We would like to thank the referee for the kind feedback and relevant comments. All the points will be addressed in blue, between the referee's comments.

The authors introduce a new concept called the Space CARBOn Observatory (SCARBO), which aims to measure CO₂ and CH₄ from a constellation of ~20 satellites in sun-synchronous low Earth orbit, with a multi-angle polarimetric aerosol instrument to account for scattering effects. SCARBO will have higher spatial coverage and revisit frequency compared to existing greenhouse gas missions. The authors assess the performance of SCARBO for a variety of scenarios, both with and without the aerosol instrument. They find that systematic errors in column-averaged CO₂ and CH₄ (XCO₂ and XCH₄) retrievals can be greatly reduced by using aerosol information from the polarimeter. The authors also parameterize results as a function of relevant parameters in order to facilitate efficient computation of error maps for CO₂ and CH₄ flux estimation.

Figure R1.1 XCO₂ averaging kernels in the case of retrieving a CO₂ profile scaling factor (full line) and a 19-layer vertical profile (dashes).

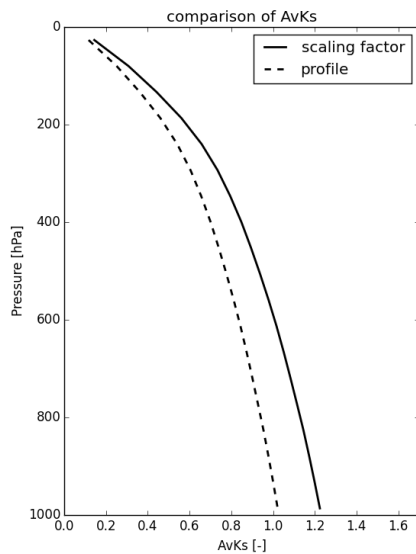
What is the impact of retrieving profile scaling factors for CO₂ and CH₄ as opposed to retrieving the vertical profile (that is traditionally done by OCO-2, for example)? Have the authors assessed the impacts on accuracy and on downstream flux estimation?

This choice also has an impact on the averaging kernel shape, which is shown in Fig. R1.1. Using a profile instead of a scaling factor tends to diminish the vertical sensitivity values compared to when using a scaling factor. Above 1 values when retrieving a scaling factor are usual, as it can be seen for instance in Fig. 2. in Buchwitz et al. (2005).
